World Forum for Harmonization of Vehicle Regulations**Working Party on General Safety Provisions****125th session**

Event Data Recorder:**UN Regulation No. 160 (Event Data Recorder)****Proposal for Supplement 2 to the 01 Series of Amendments to
UN Regulation No. 160 (Event Data Recorder)****Submitted by the expert from the Informal Working Group on Event
Data Recorder / Data Storage System for Automated Driving ***

Corridor +/- 10 Per Cent of the Full-Scale Range of the Accelerometer

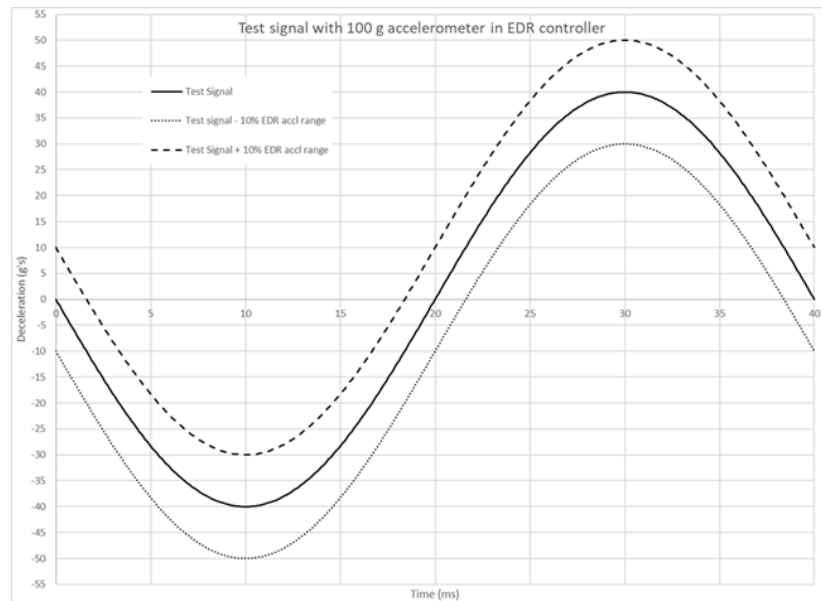
- 6.1.5. The EDR recorded acceleration trace shall be fully contained in a corridor that is +/- 10 percent of the full-scale range of the accelerometer used by the controller containing the EDR applied to the component test fixture's filtered acceleration trace. The comparison of acceleration sensor traces shall only be made on the axis the component test was conducted.

For example, if the accelerometer in the controller containing the EDR function has a +/- 100 g range, then +/- 10 g would be applied to the component test fixture's filtered acceleration trace. The EDR recorded acceleration trace shall be fully contained within that corridor (see the Figure).

- 6.1.6. **The EDR acceleration trace in paragraph 6.1.5. can be time shifted up to +/- 2ms based on the inverse of the 500 Hz sample rate to further align the data. The minimum step of the time shift may be the inverse of the sample rate of the EDR.**
- 6.1.7. **The acceleration data elements satisfy the tolerance condition if the EDR recorded acceleration trace is fully contained within the corridor established in paragraph 6.1.5., with or without following the above time shift in paragraph 6.1.6.**
- 6.1.8. **If the recommended waveform cannot realize algorithm wakeup due to the reason of manufacturer’s algorithm strategy, the manufacture may select a waveform, or amplify the suggested waveform. The waveform used for the EDR acceleration data accuracy shall be provided for review, if it is different than the waveform defined in the verification process."**
